SERVICE BULLETIN

M-1200A

Safety Recall Code 0128

2007 XL VOLTAGE REGULATOR

Figure 1. Safety Recall Code 0128—Kit 94507

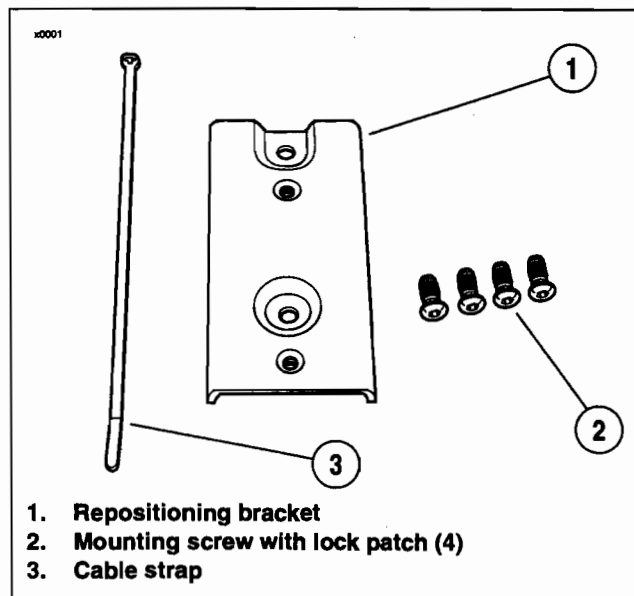
1. Obtain recall kit (Part No. 94507). See Table 1. See Figure 1. This kit consists of a repositioning bracket, four mounting screws (with lock patches) and a cable strap.
2. Position vehicle upright on a suitable lift.

Figure 2. Unbolt and Remove Voltage Regulator

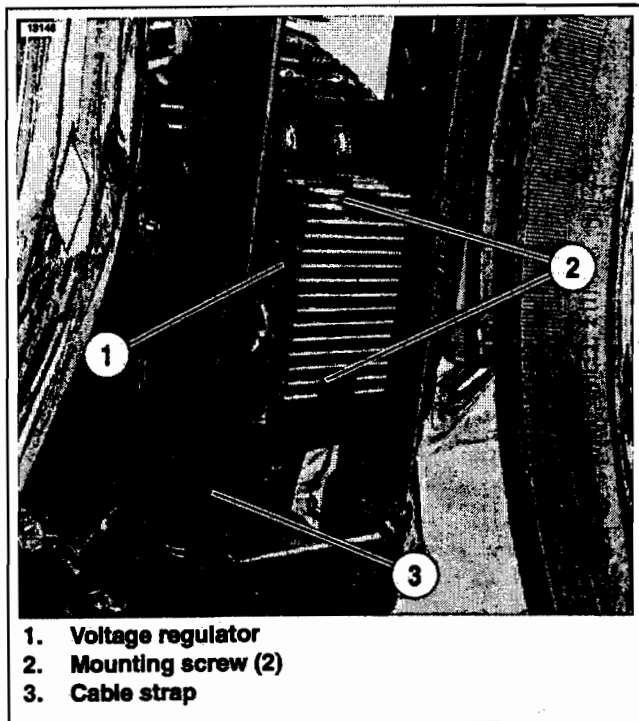
3. Remove Maxi-Fuse.
4. See Figure 2. Cut cable strap (3) that secures stator harness and neutral switch wire to vehicle frame.
5. Remove two screws (2) and voltage regulator (1) from voltage regulator bracket on vehicle frame. Discard mounting screws. They will not be reused. Position voltage regulator to the side, out of the way.
6. See Figure 3. Mount repositioning bracket (1) onto original voltage regulator bracket on frame with two **new** screws (2) from recall kit. Make sure repositioning bracket is oriented as shown in the photo, so that voltage regulator mounting holes (3) are below repositioning bracket mounting holes. Tighten screws to 30-60 in-lbs (3.4-6.8 Nm).

Figure 4. Mount Voltage Regulator

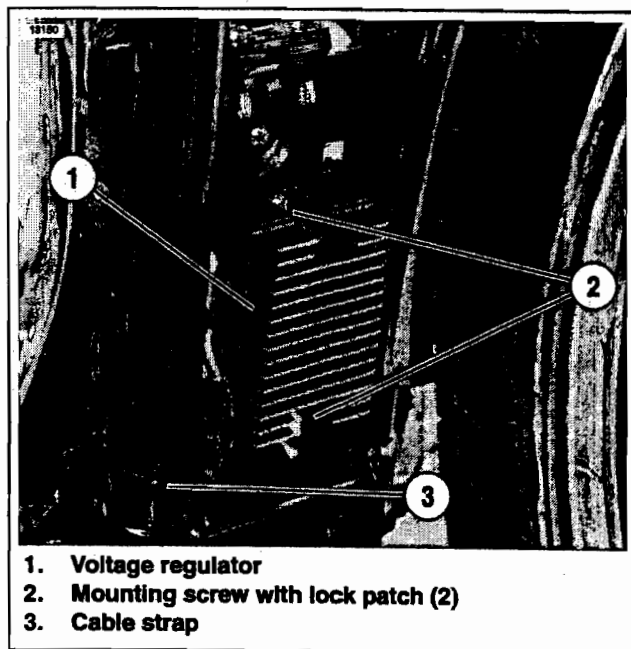
7. See Figure 4. Mount voltage regulator (1) onto repositioning bracket with remaining two **new** screws (2) from recall kit. Tighten screws to 30-60 in-lbs (3.4-6.8 Nm).
8. Locate cable strap in recall kit. Wrap cable strap (3) around stator harness, neutral switch wire and vehicle frame. Tighten cable strap securely. Cut off excess strap material.
9. Install Maxi-Fuse.
